DEPARTMENT OF DESIGN AND CONSTRUCTION  
CITY AND COUNTY OF HONOLULU

Subject: Central Oahu Ambulance Facility  
TMK: 9-4-122: 103  
Final Environmental Assessment  
Finding of No Significant Impact

Prepared by the Department of Design and Construction pursuant to Chapter 343, Hawaii Revised Statutes (HRS)

Figure 13: Zoning Map

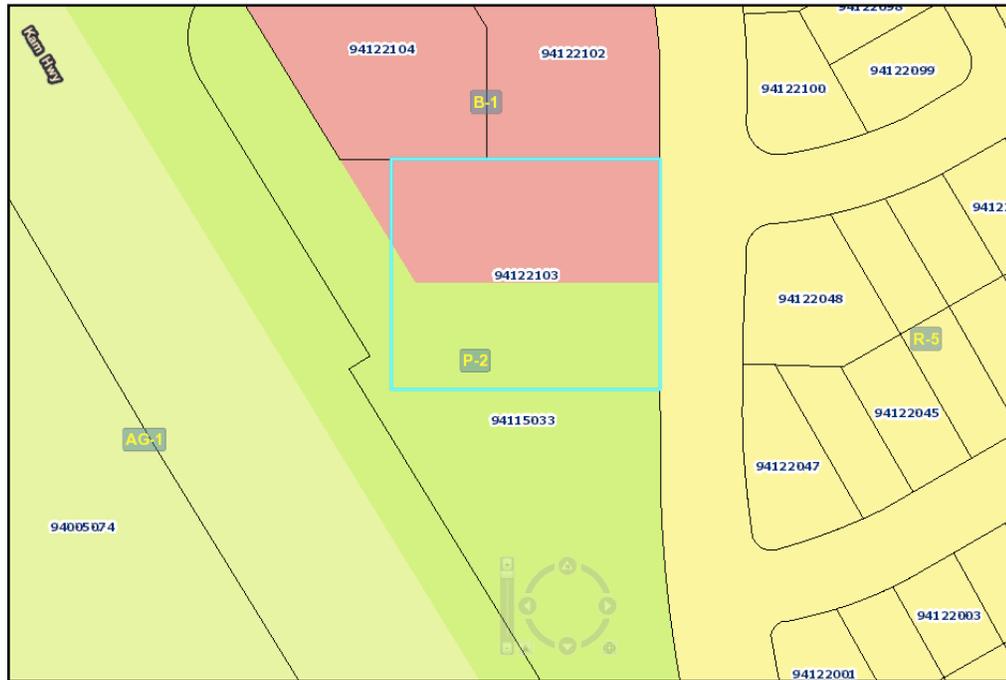
1. A zoning map of the site and general vicinity should be added.
2. The zoning district boundary line and required yards should be shown on the site plan.
3. The required yards and height setbacks should be shown on the building elevations.

1. A zoning and vicinity map will be included in the Final Environmental Assessment
2. The zoning district boundary line and required yards are now included in the Site Plan
3. The required yards and heights are now shown on the elevation plans.
